SECY-82-414

SUBJECT: DIABLO CANYON DESIGN VERIFICATION PROGRAM -
PHASE II RECOMMENDATIONS

PURPOSE: In accordance with the Commission's request (COMJA-82-6) of July 27, 1982, this paper provides the staff recommendations regarding Phase II of the Diablo Canyon Independent Design Verification Program (IDVP) and its relationship to the ongoing Phase I program.

Figure 2: IDVP/PG&E Activities

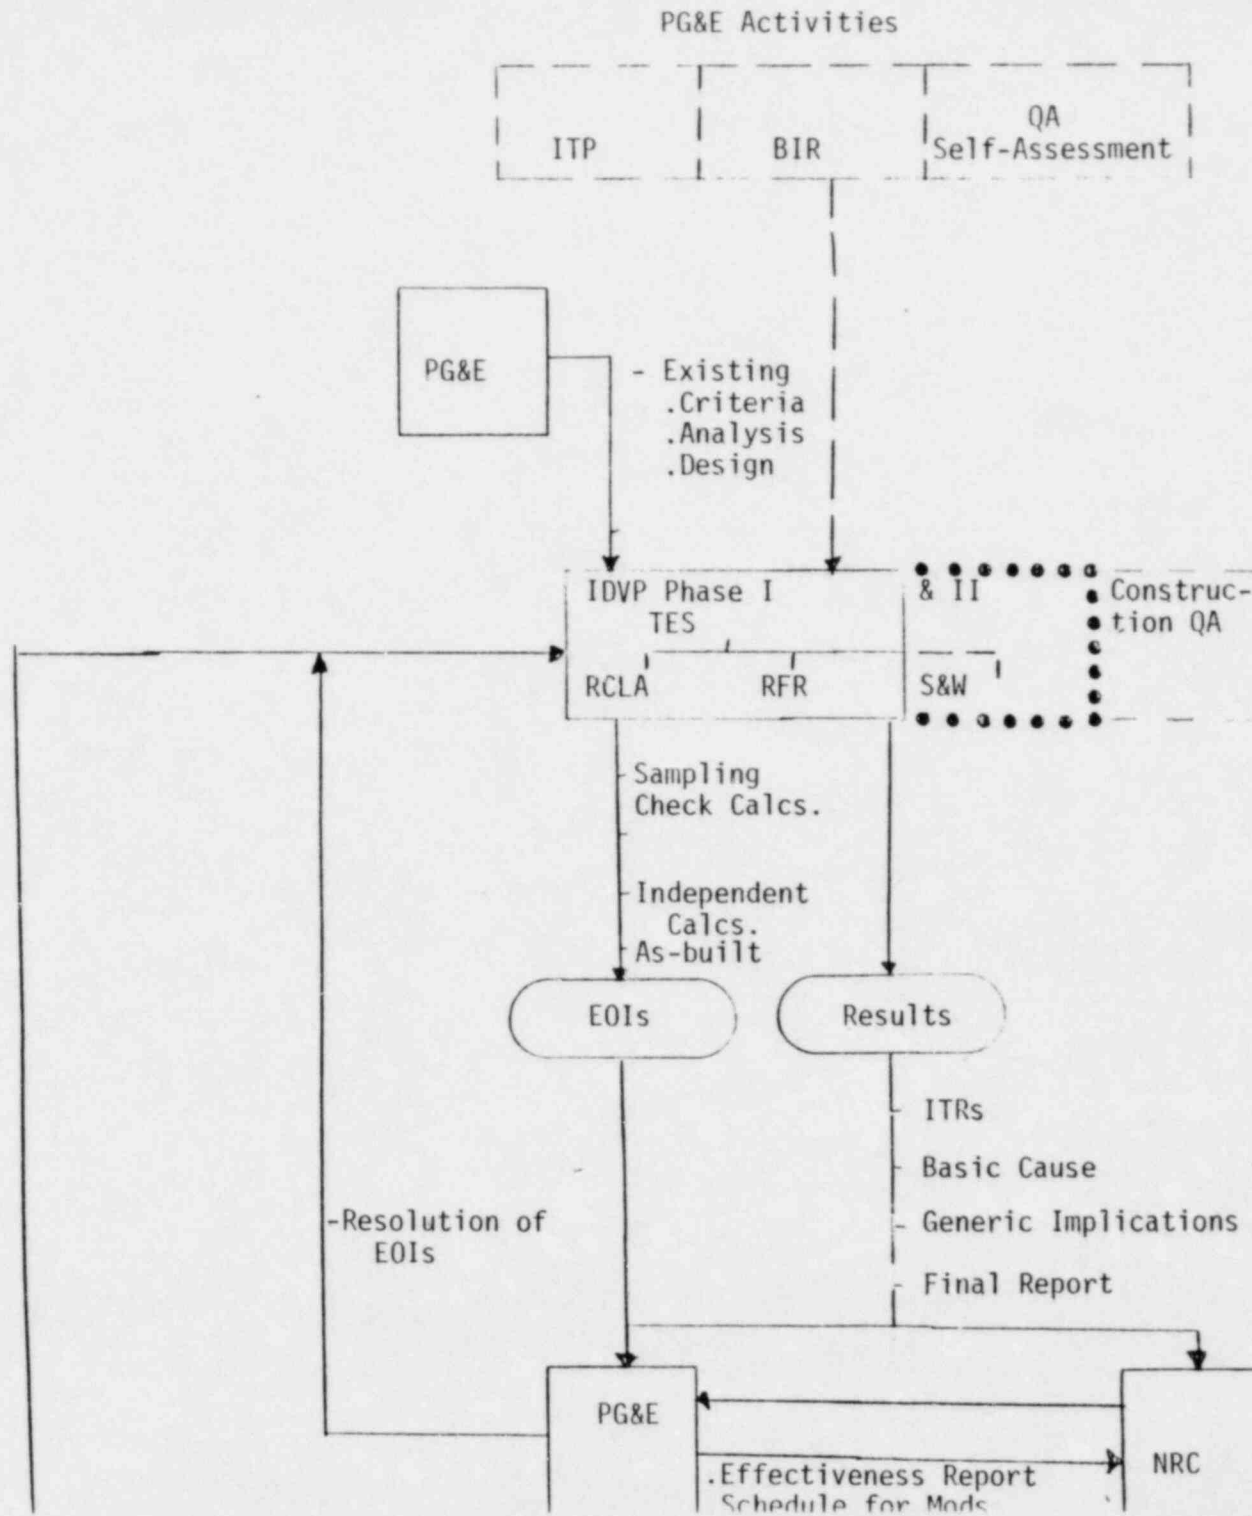
The IDVP has presented plans to include the results of the expanded PG&E activities as inputs to the IDVP program. This proposal is included in the Figure 2 flow chart.
